Intersection ID: 14439	Main Street: S_TORRENCE_ST	Cross Street: ELLISON_ST	Location:	E
ADA ID: F1C5F688718D	Ramp Type: Perp	Initial Pass/Fail: Fail	Overall Compliance: No	Severity Score: 25

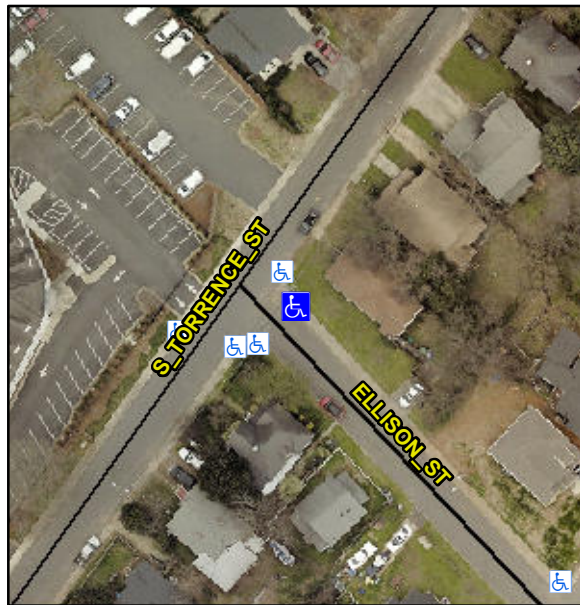
Compliance	Description	Data	Compliance	Description	Data
N/A	Ramp Length (in)	54.0	No	Ramp Slope (%)	13.1
Yes	Ramp Width (in)	48.0	Yes	Ramp XSlope (%)	1.6
N/A	Flare Type LT	N/A	N/A	Flare Type RT	N/A
N/A	Flare Slope LT (%)	N/A	N/A	Flare Slope RT (%)	N/A
N/A	Flare Traversable LT?	N/A	N/A	Flare Traversable RT?	N/A
N/A	Landing Length (in)	N/A	N/A	DWS Provided?	N/A
N/A	Landing Width (in)	N/A	N/A	DWS Contrast?	N/A
N/A	Landing Slope (%)	N/A	N/A	DWS Length (in)	N/A
N/A	Landing X Slope (%)	N/A	N/A	DWS Full Width?	N/A
N/A	Landing Curb? (Y/N)	N/A	N/A	DWS Offset (in)	N/A
N/A	Shared Landing?	N/A			
N/A	Gutter Ponding?	N/A	N/A	Gutter Slope (%)	N/A
N/A	Gutter Lip Ht (in)	N/A	N/A	Gutter X Slope (%)	N/A
N/A	Painted X Walk1?	No	N/A	Painted X Walk2?	N/A
	X Walk 1 Direction	To SW		X Walk 2 Direction	N/A
N/A	X Walk 1 Width (in)	N/A	N/A	X Walk 2 Width (in)	N/A
	X Walk 1 Slope (%)	1.1		X Walk 2 Slope (%)	N/A
	X Walk 1 X Slope (%)	2.5		X Walk 2 X Slope (%)	N/A

Remove & Replace Entire Ramp.
